Updates to design of Panny GH1 remote shutter control.

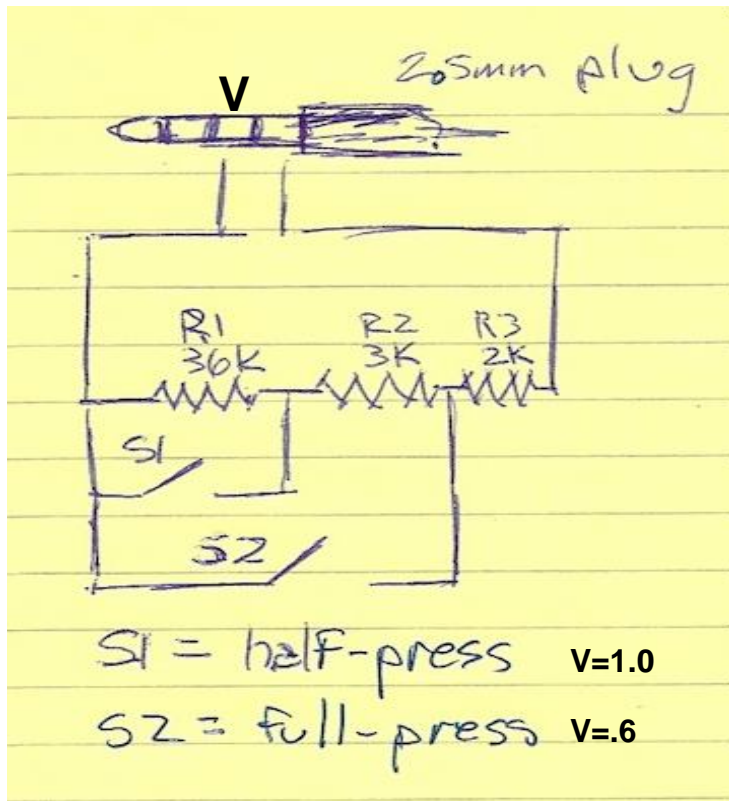
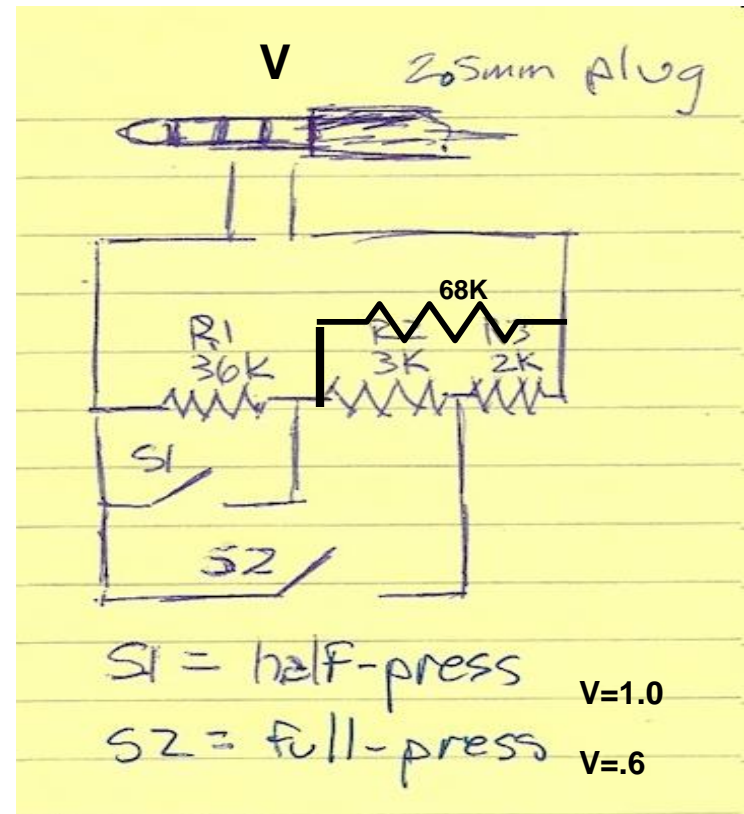
did not work for new Gh1 ver 3 firmware. After substantial amount of trial and error tinkering I discovered the following modifications make it work. Apparently voltage must be increased to 2.5 V when plugged in otherwise the firmware did not recognize that it was plugged in.

### Original design would not work

no button press v=2.0

### Modified design

no button press v=2.5
